Staff Report & Recommendation

Historic Preservation Board

SUBJECT: HPB19-0341, **1751, 1757 & 1775 Collins Avenue.**

Raleigh Hotel, 2016 Photograph (rooftop additions highlighted in red proposed to be removed)

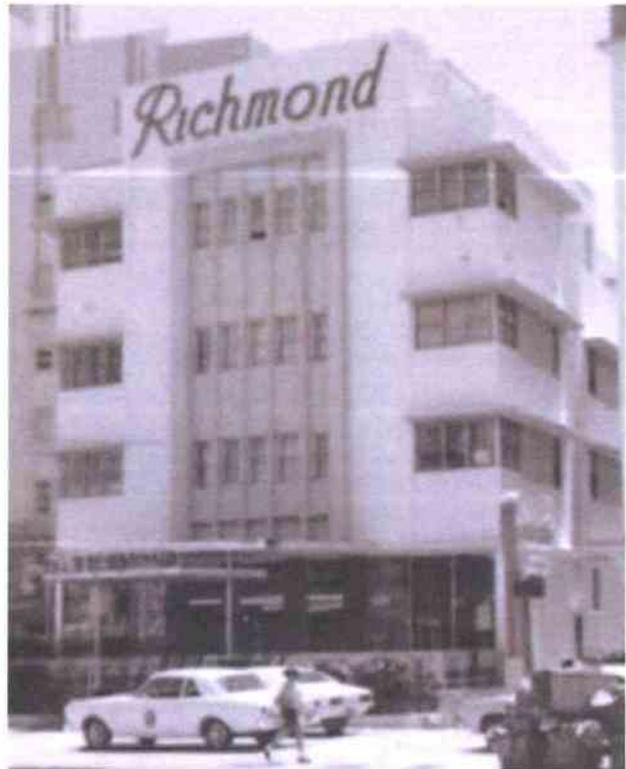
Additionally, as part of this submittal, an expanded scope of restoration is proposed including the removal of several inappropriate rooftop additions (see image below). These rooftop additions have an exceedingly adverse impact on the integrity of the original 1940 Dixon design and their removal will restore the skyline of the Raleigh Hotel to its former grandeur. Other notable restoration includes the reintroduction of a missing window within each set of ribbon windows along the broad curved corner of the building.

Staff is extremely supportive and enthusiastic of the expanded scope of restorative work. This additional scope in conjunction with the previously approved restoration will reposition the Raleigh Hotel as one of the most meticulously restored Streamline style hotels in the world.

- i. Consistent with the proposed plans, the following rooftop additions shall be removed: the 2-story penthouse, the 1-story enclosure at the southwest corner of the building, the 1-story enclosure at the north west corner of the building and a portion of the rooftop addition at the 8th level, in front of the north side of the tower element.

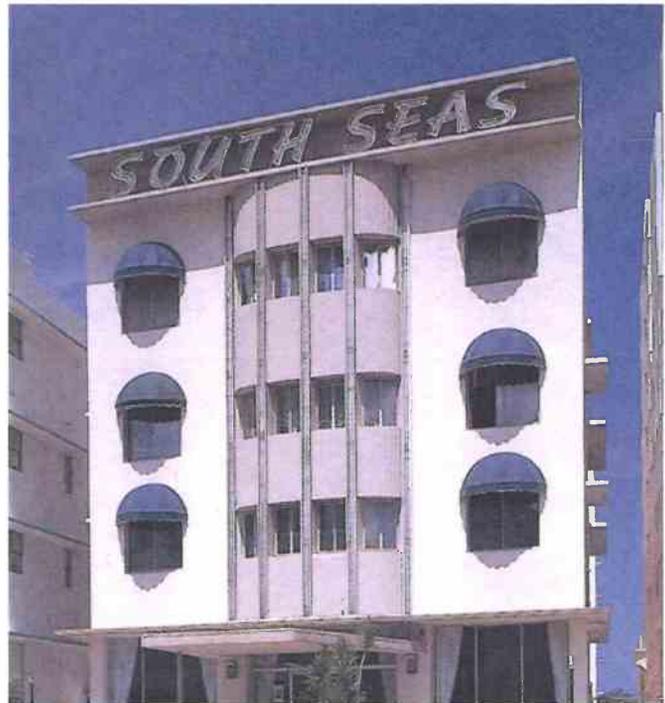
Within the original public lobby, the applicant is proposing to retain and restore significant architectural features including the terrazzo flooring and several presumed Art Deco era fixtures including the elevator details and lighting elements. Additionally, the applicant is proposing to remove the non-original wood paneling. In combination with the restoration, the applicant is proposing several alterations to the lobby including the demolition of the lobby ceiling and second floor slab creating a double-height space. Staff would note that the existing ceiling contains no significant architectural features and the applicant is proposing to introduce a lighting ledge around the perimeter of the lobby, demarcating the location of the original ceiling.

Additionally, the applicant is proposing to construct a 2-story attached addition to the rear of the portion of the Richmond Hotel building proposed to be retained. The double-height addition will contain a dining room for a proposed restaurant. The design of the addition had been directly inspired by the original Richmond Hotel building. In order to more subtly differentiate the addition from the historic building, staff recommends that the proposed breeze block and uppermost eyebrow be eliminated.
